HISTORIC AND DESIGN REVIEW COMMISSION

HDRC CASE NO: 2020-448
ADDRESS: 415 HAYS ST
LEGAL DESCRIPTION: NCB 528 BLK 1 LOT 12
ZONING: IDZ-1, H
CITY COUNCIL DIST.: 2
DISTRICT: Dignowity Hill Historic District
APPLICANT: Juan Fernandez/CVF LLC
OWNER: CVF LLC
TYPE OF WORK: New construction of three, 2-story single family residential structures
APPLICATION RECEIVED: December 18, 2020
60-DAY REVIEW: Not applicable due to City Council Emergency Orders
CASE MANAGER: Edward Hall

The applicant is requesting a Certificate of Appropriateness for approval to construct three, 2-story, single-family residential structures on the vacant lot at 415 Hays, located within the Dignowity Hill Historic District.

Historic and Design Review Commission
Design Review Committee Report

DWELLING A

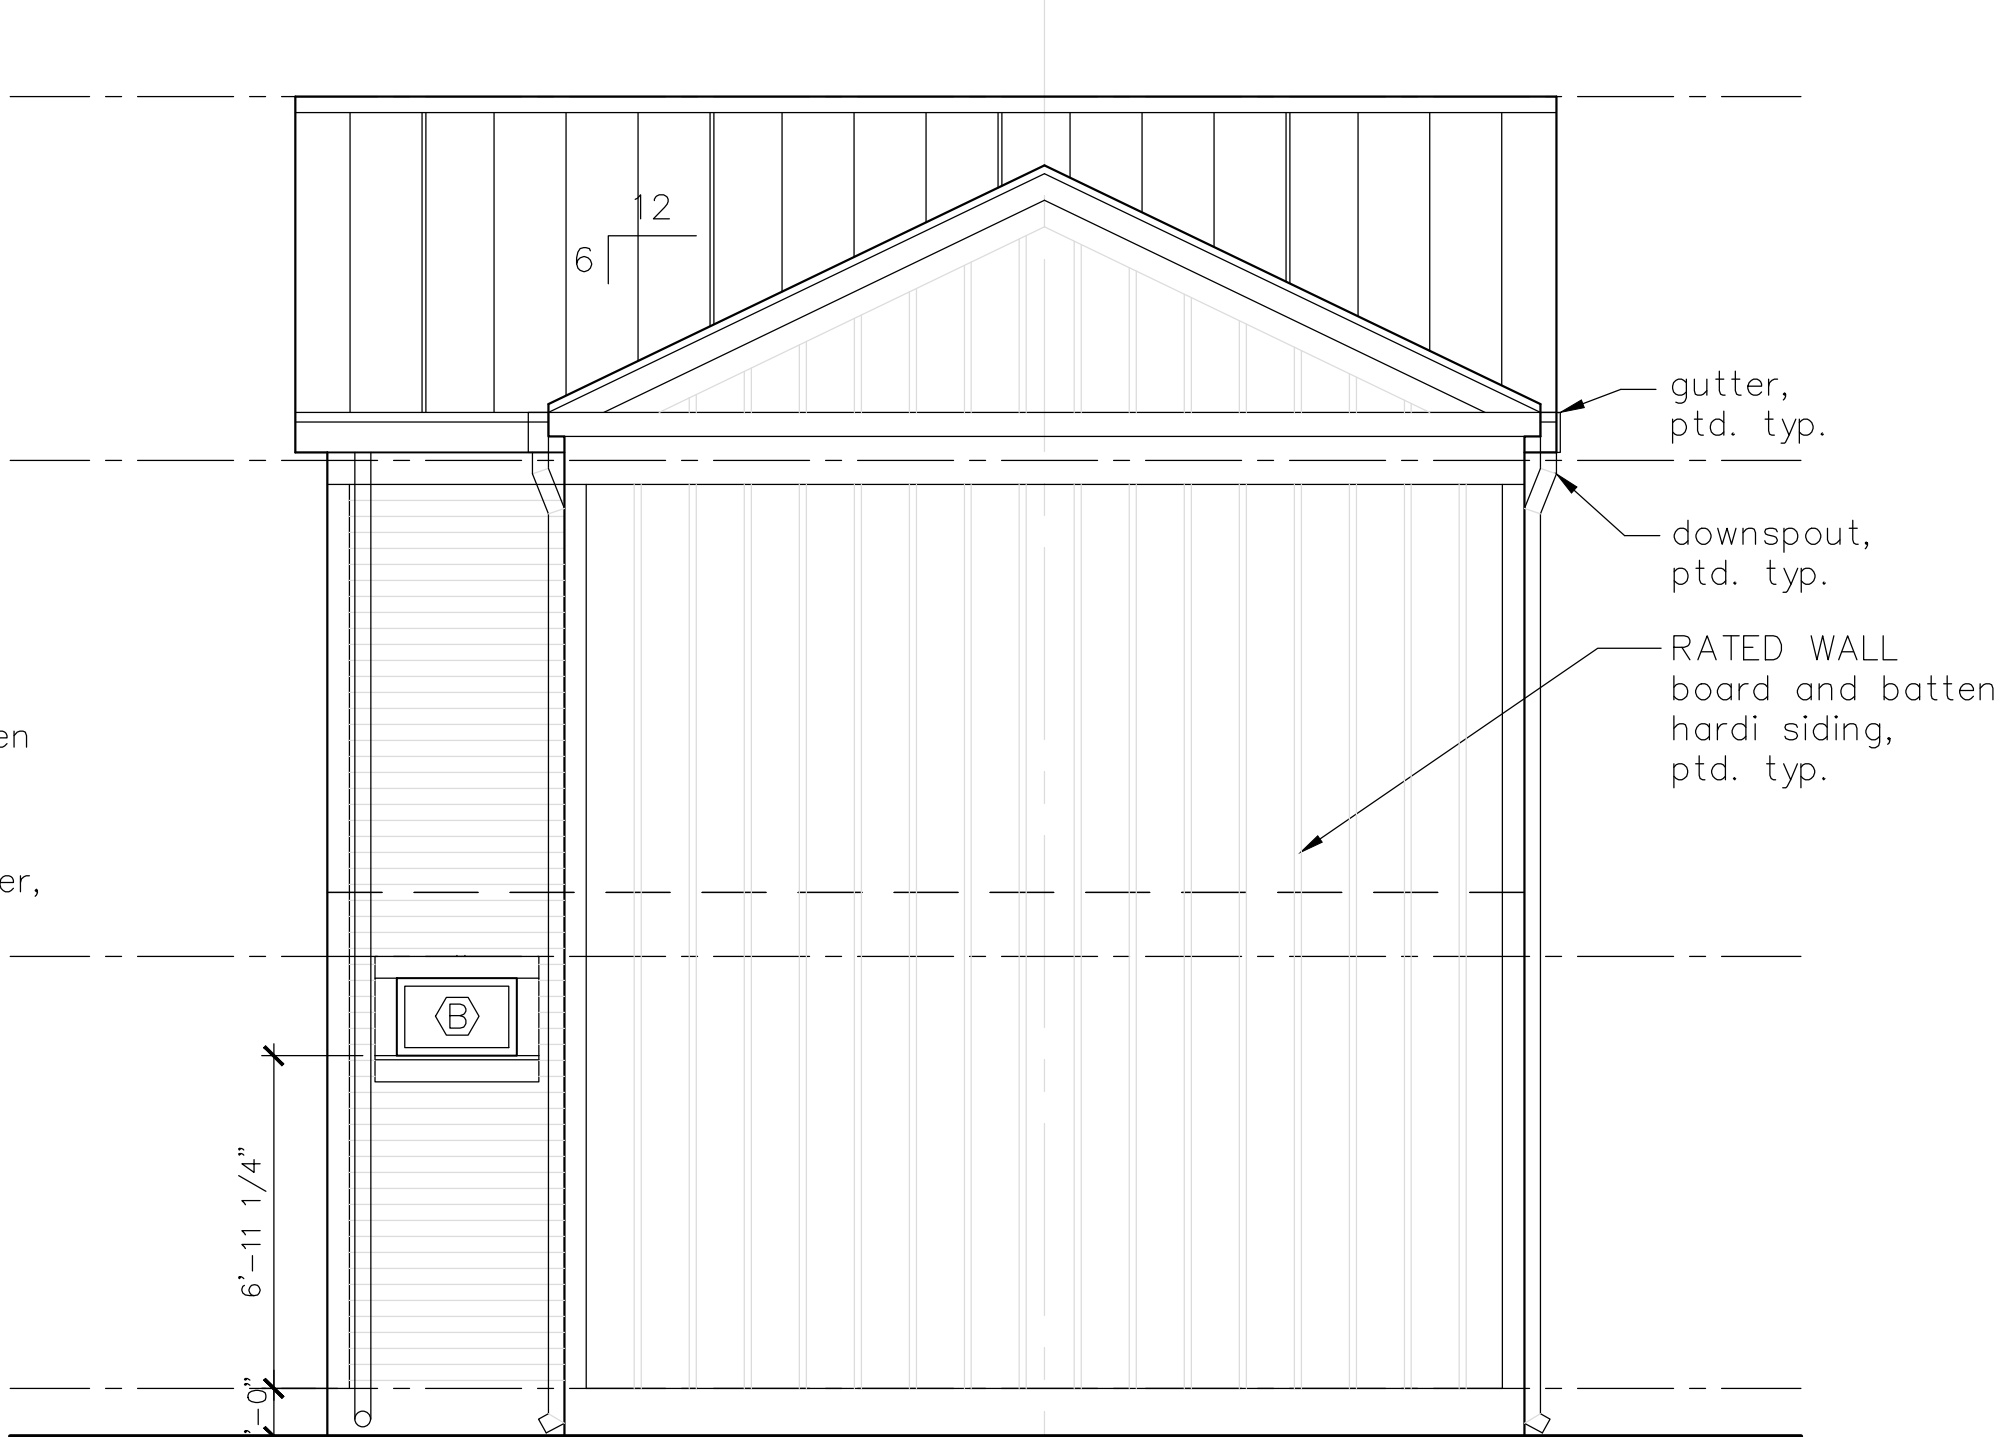
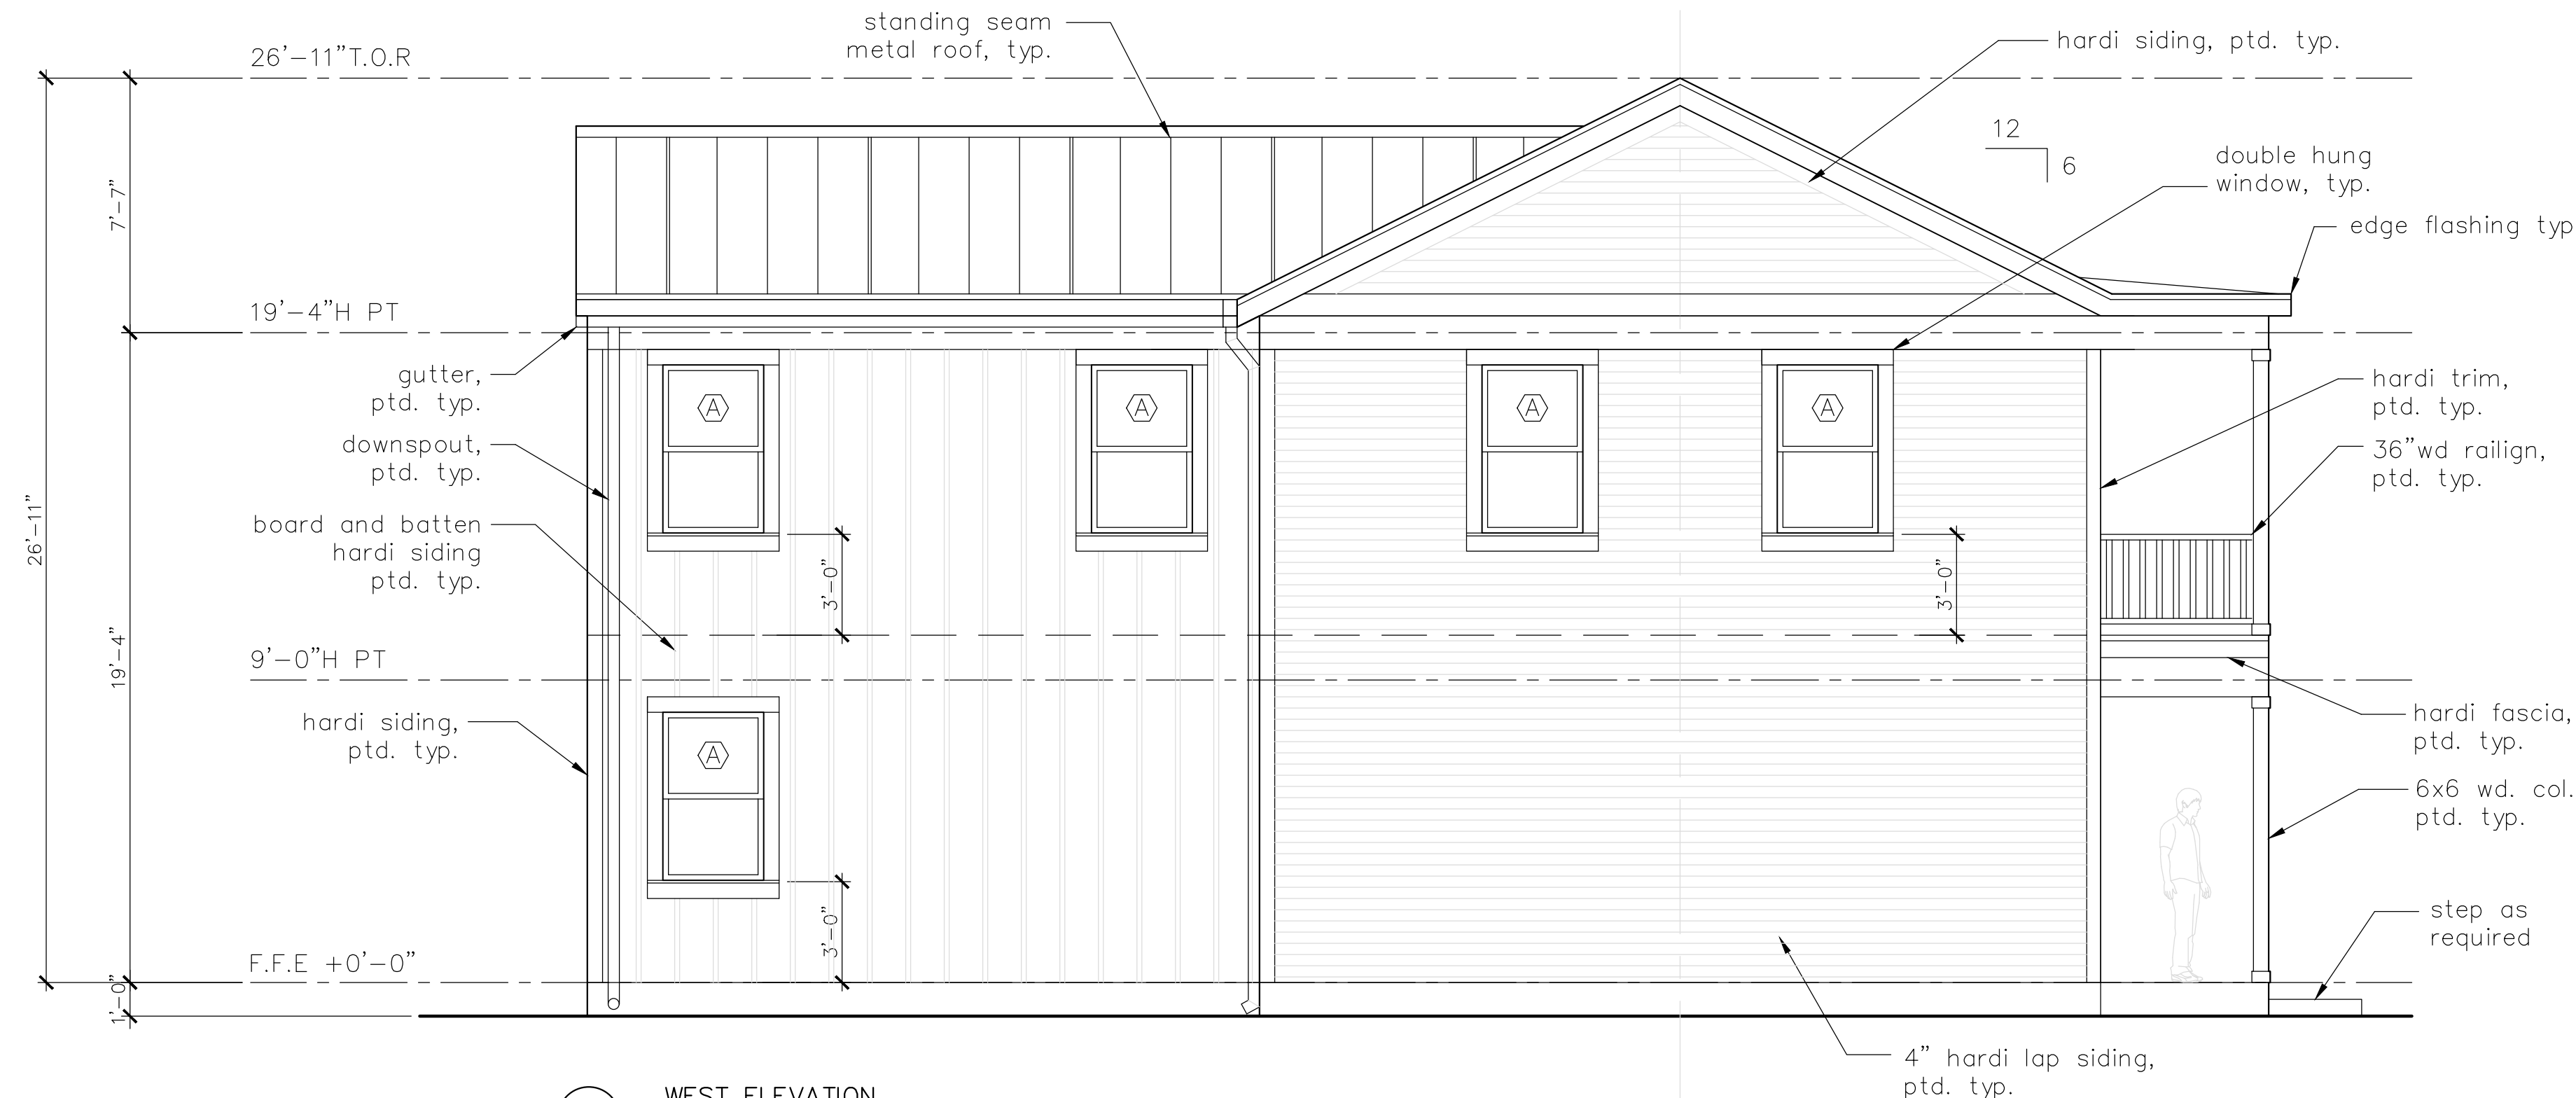
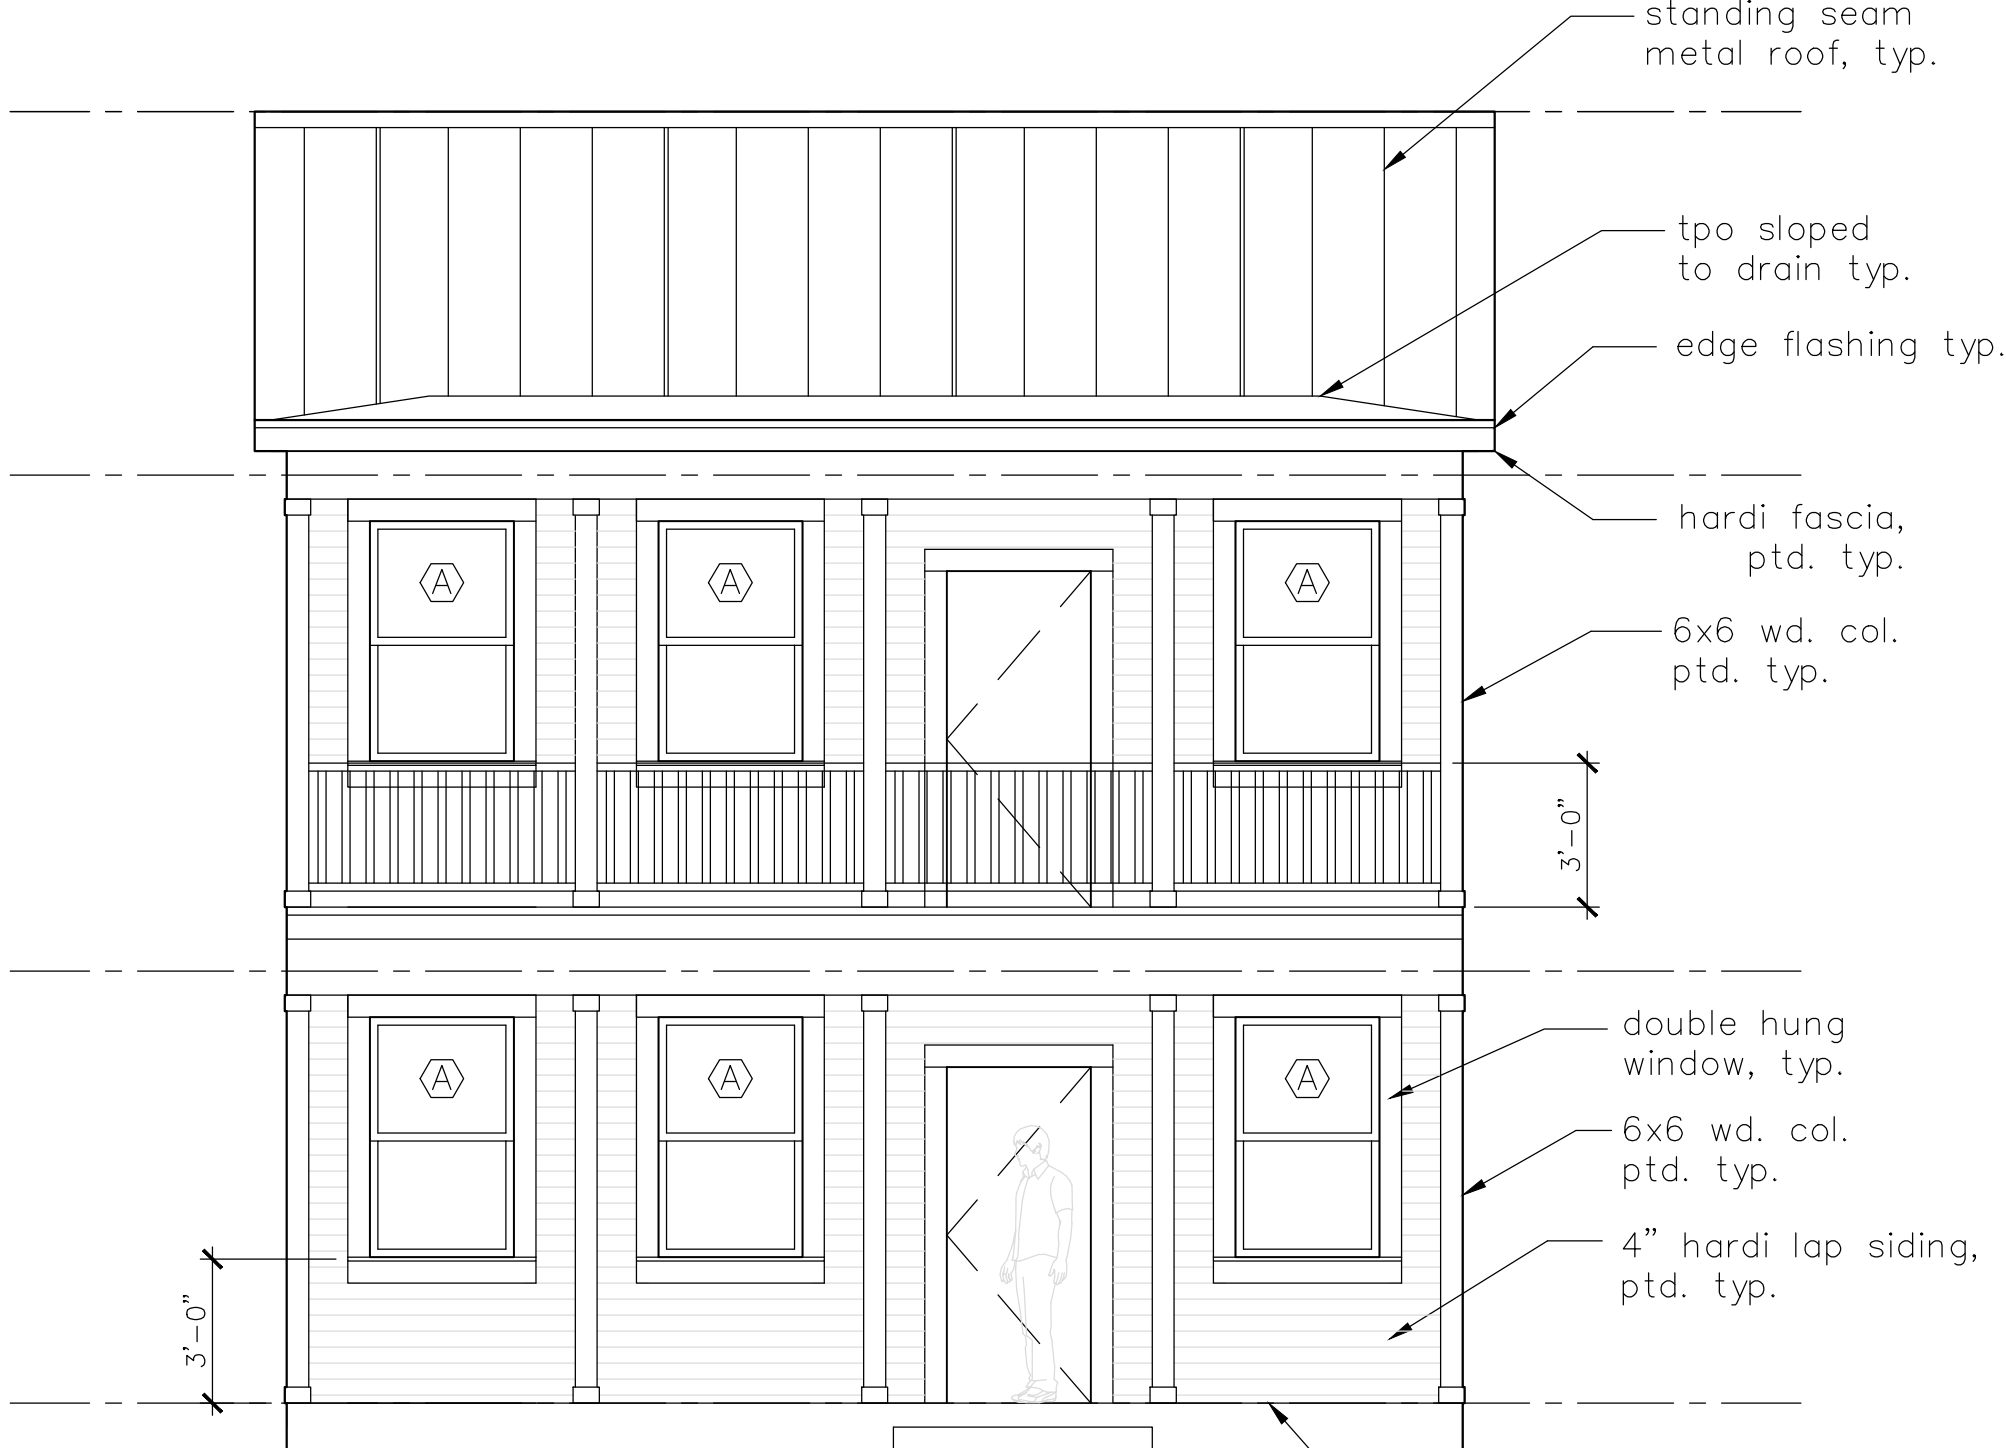
- p. PARKING – The applicant has proposed for each structure to feature attached garages. At the time of conceptual approval, the design featured open air parking, but with similar locations. Parking within the footprint of the primary structure is not found historically within the district; however, staff generally finds the proposed parking solution to be appropriate. Due to the new inclusion of garage doors, staff finds that each garage should feature two separate garage doors that feature windows.

- v. That the proposed garage doors be separated to feature two doors at each garage and that each garage door feature windows.
- vi. That the applicant produce massing for the middle and rear structures that appears to be subordinate to the primary structure on Hays, such as reduced ridge heights or one story massing at each garage.

SC: Eave details and roof overhangs need to be addressed and increased in depth.

SC: Is there an opportunity for garage doors to have windows to break up solid garage door massing?

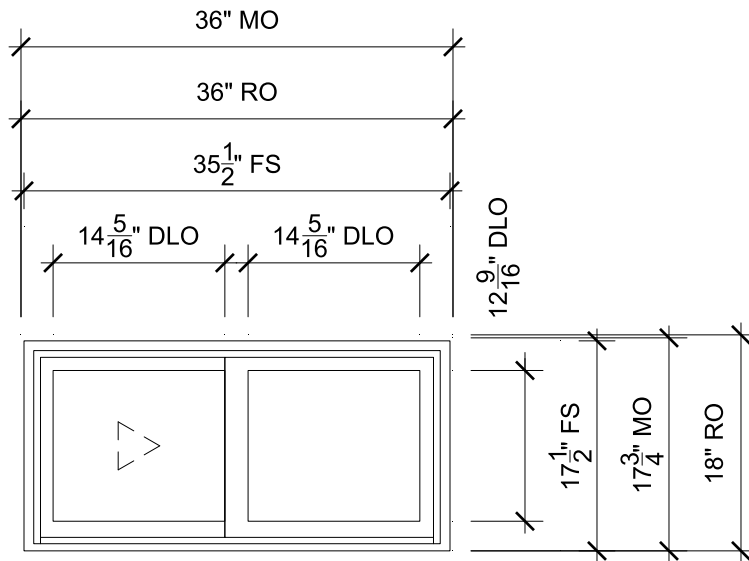
- m. WINDOW MATERIALS – The applicant has proposed fiberglass windows. Staff finds that wood or aluminum clad wood windows that meet staff's standard specifications for windows in new construction should be installed.

SC: Questions regarding window materials (JF: Proposing Marvin Fiberglass windows).

- iv. That wood or aluminum clad wood windows that are consistent with staff's standards for windows in new construction be installed, as noted in finding m and in the applicable citations.
